National Grid Norwich to Tilbury Consultation July / August 2023

Consultation Response

National Grid Norwich to Tilbury Proposals / consultation June 27 to August 21 2023

(AONB illustrated in dark green, viewfall in red. Note that map areas differ between maps.)

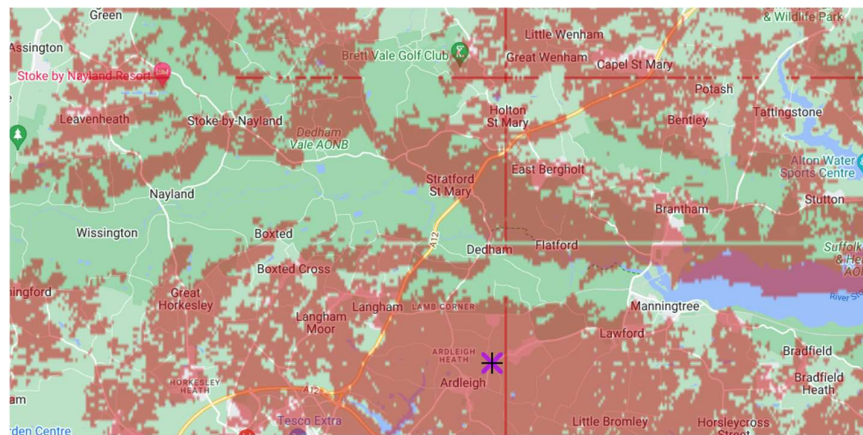
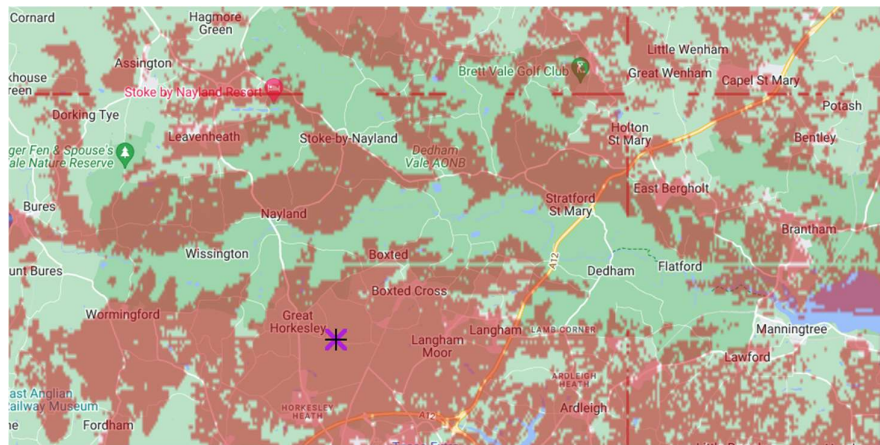
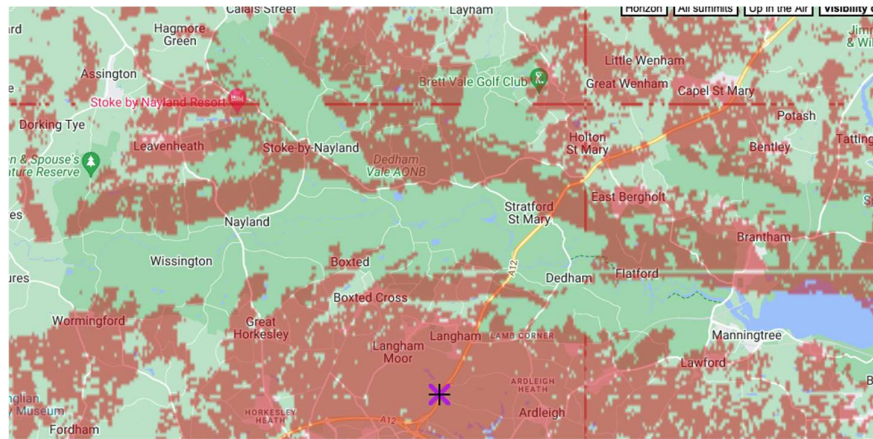
- V. The following diagrams illustrate the viewsheds within the AONB of a 50m tall pylon from sample pylons near to TB11, TB22 and TB33 respectively. As can be seen, the impacts are broad and spread across the whole of the AONB. Only the very narrowest corridor immediately adjacent to the River Stour where land falls away quickly to 7m above sea-level is unimpacted. The addition of impact from the remaining pylons significantly increases the overall harm. There are numerous listed buildings throughout this area which would be negatively impacted as a result and where the setting is important. It is not plausible that, aside from the use of undergrounding, damage in this area to each listed building could be mitigated.

- ix. The industrialisation of the area and of the AONB through use of Pylons in this area is entirely incompatible with the setting and will do significant and lasting harm to an area which, per the Holford rules, should be 'avoided altogether'. ***The section from TB1-TB35 must be under-grounded.***

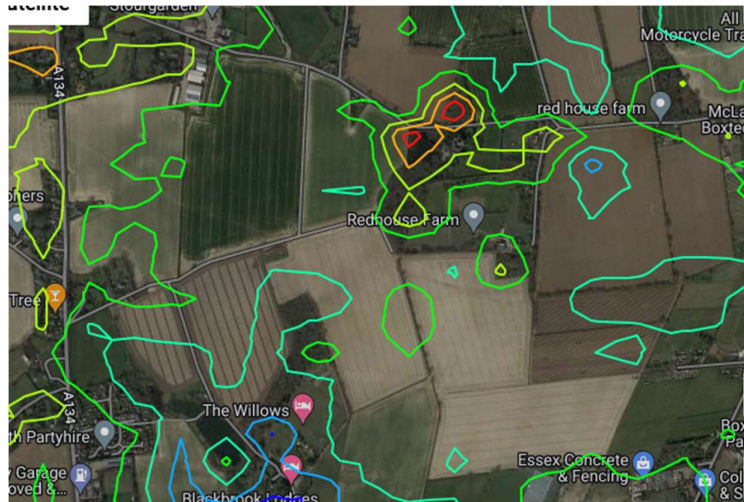
- i. Horlock Rule (2) states that sealing end compounds should "as far as reasonably practicable seek to avoid altogether international and nationally designated areas....".

- ii. Holford Rule (1) states “avoid altogether, if possible, the major areas of highest amenity value, by so planning the general route of the first line in the first place, even if the total mileage is somewhat increased in consequence. ”
- iii. The siting of the sealing end compound at Horkesley Plantation necessitates multiple gantries and pylons in a small area in close proximity to both the AONB and also to a very significant concentration of Listed Buildings at Great Horkesley (including a large number of Grade II listed and one Grade II* listed very near to the route and whose setting and tranquility would be harmed).
- iv. Land in this area is exceedingly flat, with only a few metres between the local peak (55m, Redhouse Farm) and the intended location of the Sealing End Compound (50m) at TB34/35. Land contours are illustrated below.

- ix. The location at TB34/35 fails to comply with either Holford or Horlock rules. Against this backdrop, and notwithstanding the comments above in respect of the whole route in this area, ***TB 34/35 is unsuitable as a location for the Sealing End Compound, which must be significantly further East if it is to be located along the route currently indicated.***

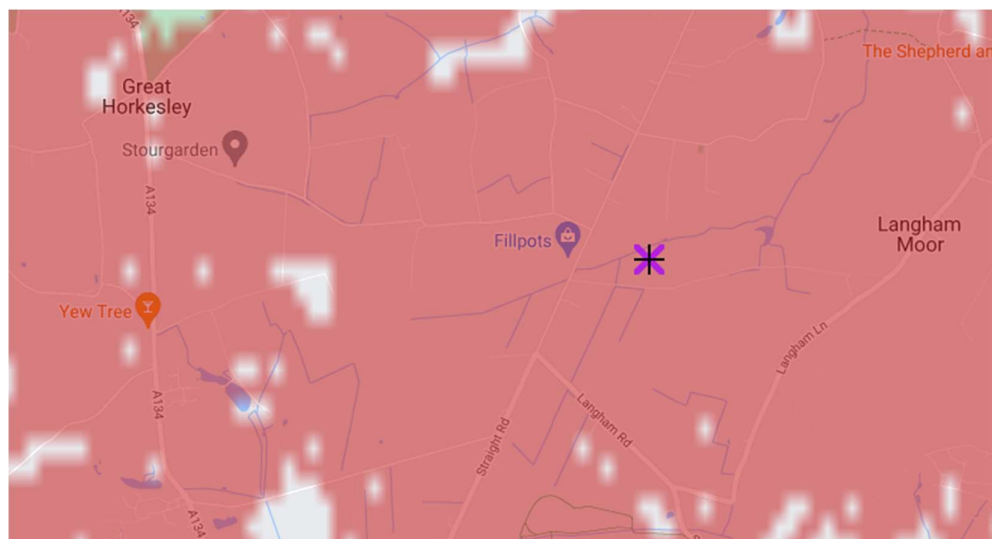
- v. Given the flatness of the land, and towers in this area will be visible throughout the area as illustrated in the viewfall map below. There are no significant dips in the area and no other features capable of providing screening to or from either the listed buildings or the AONB. As already illustrated above, towers in this location will be clearly visible across a wide area of the AONB and due to the close proximity will cause significant harm.

20) Great Horkesley to Little Horkesley

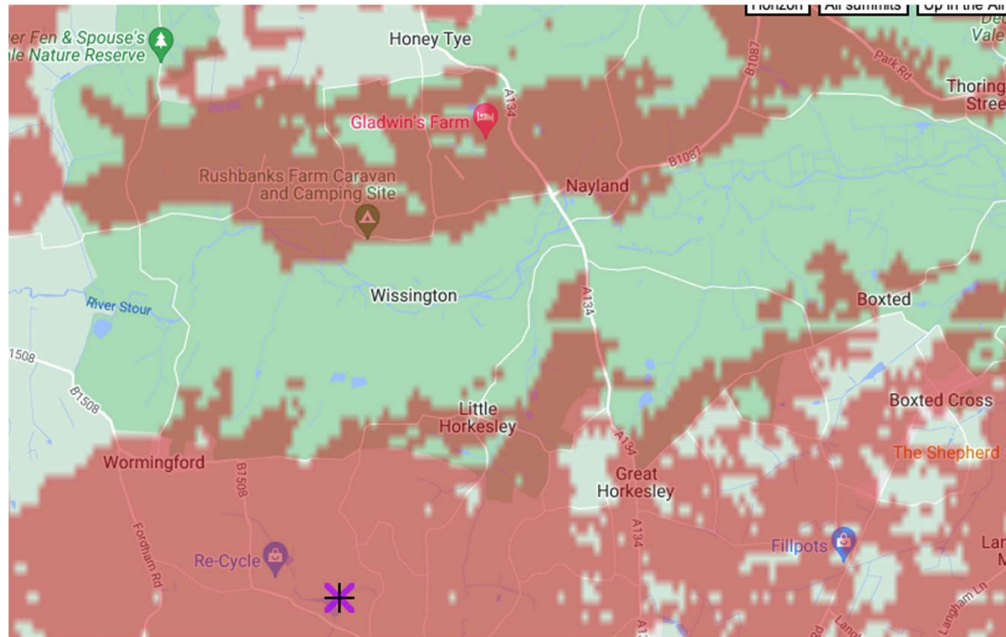
- i. The Holford Rules require the avoidance of residential areas. Use of underground cables through residential land is unacceptable and to be avoided at all costs.

- ii. Given the rural nature of the area many buildings known as “Farm” or “Barn” are in fact residential and not agricultural or commercial properties. The underground section of route must be thoroughly reviewed in order to ensure that trenching does not occur through residential land or parkland / paddock land associated with residential properties. Agricultural land should be favoured in all cases. (Feedback as to construction in Agricultural land is set out below).

- iii. In particular, the split cable arrangement at Knowles Barn (Farm) proceeds directly through residential land and is not acceptable. Cables should not be routed through or oversail residential land and this route segment requires modification.

- iv. The position of the Sealing End Compound is unsuitable for the reasons set out below and must be relocated at least as far as the alternative site at TB40/41 highlighted in your Design Development Report.

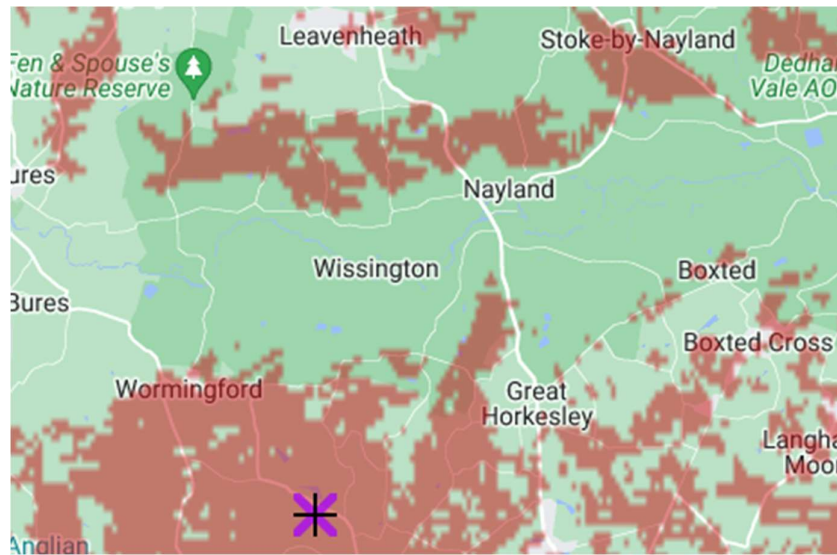
- vi. The choice of site fails in respect of Horlock Rule (2) and Holford Rule (1) in that it is readily visible from within the AONB as illustrated in the viewfall map below. It is similarly readily visible within the Stour Valley Project Area which as highlighted in Chapter 5 of the CPRSS is also an environment deserving of special recognition and protection. The situation is made more problematic by the concentration of infrastructure in a small space.

- vii. The selected Sealing End Compound and Pylon sites similarly fail Horlock Rule (2) and Holford Rule (1) in that they are also in close proximity to and readily visible from Listed Buildings and / or curtilage of Listed Buildings at each of:

Significant harm would result to these Listed Buildings and to their settings from the currently proposed site. The planning history of these buildings indicates a significant number of occasions on which residents have been required to modify proposals in order to ensure that views of the buildings across the landscape are protected and preserved, indicating their importance and the importance of views to/from these buildings. ***The choice of site is unsuitable as it would harm these buildings, hence contravenes the Holford Rules. The site cannot be moved closer to the AONB as this would also contravene the Holford Rules and hence needs to be relocated to the south, further along the route.***

- xi. For the reasons set out above, the selected location for Sealing End compound at TB36/37 is greatly detrimental to a protected landscape, unsuitable and an alternative must be identified.***

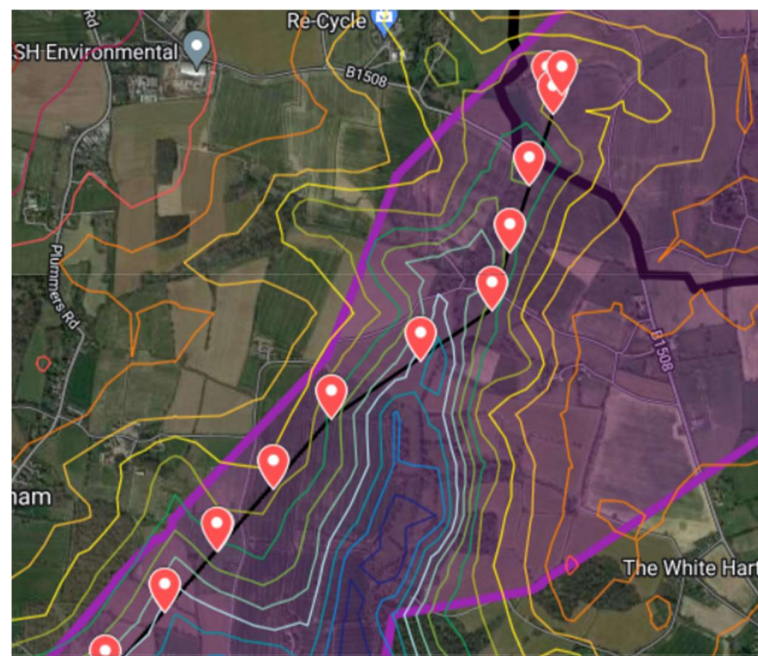
- TB40 is situated some 16m below the ridge and is located within the start of a narrow valley. As highlighted in your report, the fields around TB40 are well screened by tall trees from each of the nearby listed buildings. The site is significantly less visible from within the AONB. Pylons would not frame the entry to the AONB or Stour Valley Project Area. Pylons located here will cause significantly less harm to the AONB than those at TB36/37 as illustrated in the viewfall map below.

- Elevations are illustrated on the map below commencing at TB37 (top right) through to TB47 (bottom left).

- Notwithstanding what is written below, the alternate site at TB40 offers significant advantages to the selected site at TB36/37, would reduce harm to both the AONB and Listed Buildings, and hence would be strongly preferable given that you currently intend to build at both. This change can be easily made and hence **is required** when measured against Holford Rule (1).
- ***Undergrounding must be extended to at least the alternate site at TB40, but ideally as far as TB42, in order to mitigate impact on protected landscapes and listed buildings.***
